SUBJECT: Addendum #1 HWAY 19-29 ASPHALT CONCRETE FOB

This Addendum, issued to bid document holders of record, indicates changes to the bid documents for the *HWAY 19-29 Asphalt Concrete FOB* Bid Opening April 5, 2019.

Schedule B

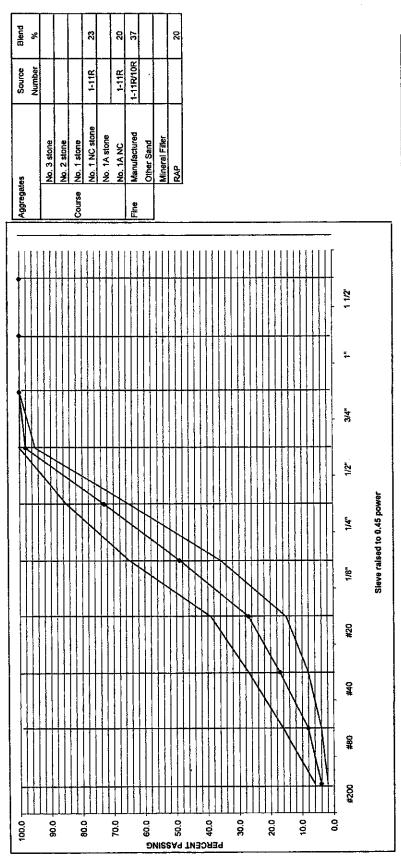
NYSDOT Type 6 Top

eve Size ((mm)	#200	08# #	#40	#20	1/8"	1/4"	1/5"	3/4"	- -	11/2"	% PGB	Binder Grade
	General Limits	2-6	4-16	8-27	15-39	36-65	65-85	95-100	100	100	100		
Passing	JMF Range	2-6	4-12	10-24	20-34	42-56	99-99	95-100	100	100	100	5.4-6	PG64-22
	Target Value	4	8	-11	27	49	73	86	100	100	100	5.6

Revised

Schedule C

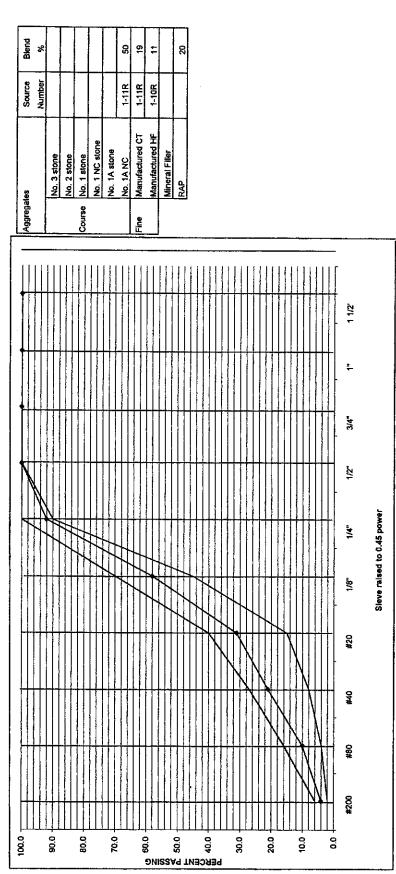
NYSDOT Type 7 Top

#200	#80	#40	#20	1/8"	1/4"	1/2"	3/4"	1.	1 1/2"	% PGB	Binder Grade
eral	Limits	2-6	4-16	8-27	15-40	45-70	90-100	8	100	8	100	5.7-8.0	
1F Ra	Jge I	2-6	6-14	14-27	24-38	52-64	90-100	ş	9	\$	100	5.7-6.2	PG64-22
rget V	alue,	4	10	21	31	28	92	8	8	8	100	5.8

Revised
